## SITE PLAN REVIEW AND APPEARANCE BOARD

### 7<sup>th</sup> Avenue Banyan

Meeting	File No.	Application Type
December 14, 2022	2022-092-SPF-SPR-CL5	Class V Site Plan with Waiver
Applicant / Property Owner		Authorized Agent
West Atlantic Development Company, LLC		John W. Szerdi, LEED AP of Living Designs Group Florida Architects, Inc.

Provide a recommendation to the City Commission for a CBD waiver request associated with a Class V Site Plan to allow the use of the Porch frontage type, in place of the required Storefront or Arcade with Storefront frontage type, associated with the construction of a 16,298 square foot, three-story mixed-use building at 625, 633, and 645 West Atlantic Avenue, also known as 7<sup>th</sup> Avenue Banyan.

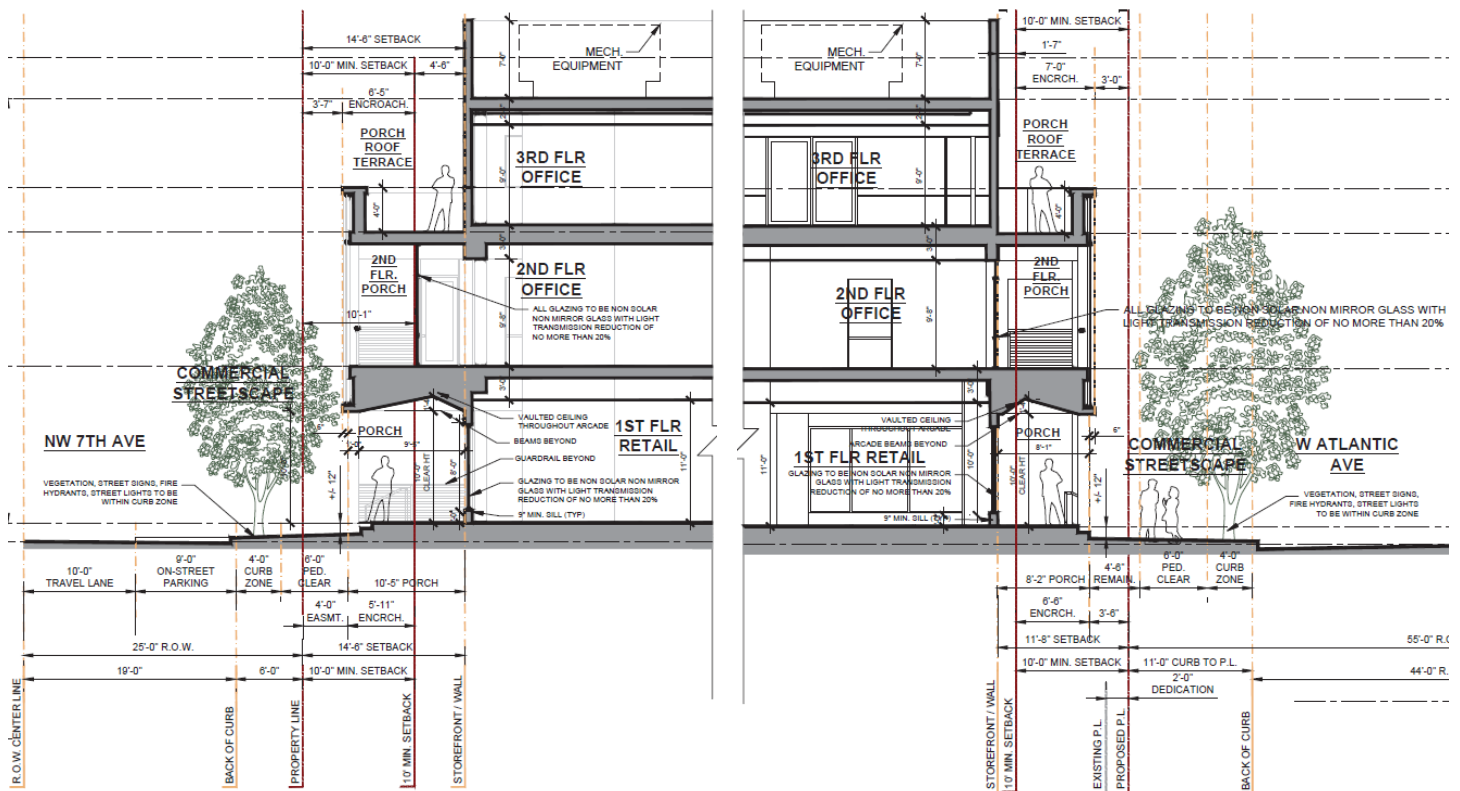
**Table 4.4.13(E), Dimensional Requirements for Porches**, indicates that porches are allowed to encroach up to eight feet into the building setback, provided the curb zone and pedestrian clear zone are free from obstruction. The table below provides the minimum and maximum dimensional requirements for Porches as well as the provided Porch dimensions for the project.

The streetscape sections below illustrate the streetscape dimensions from the right-of-way centerline to the Storefront wall. The Porches do not encroach more than eight feet into the minimum setback, and the minimum curb zone and pedestrian clear zone comply with the minimum widths in the LDR. While a Porch is not allowed to extend over the public sidewalk like an Arcade, the proposed Porch functions similarly to an Arcade with Storefront. For example, the Porch provides recessed lighting, which is a common feature in Arcades. The ground floor of the south façade has 84% transparency, and the ground floor of the west façade has 94% transparency, which is consistent with the highly-transparent Storefront frontage type. Additionally, like an Arcade, the proposed Porch is covered, unglazed, and runs linear to the south and west sides of the building supported by columns. A shaded environment is provided for pedestrians; however, unlike an Arcade, the public sidewalk runs parallel to the Porch and there is a one-foot elevation absorbed by steps from the sidewalk to the Storefront.
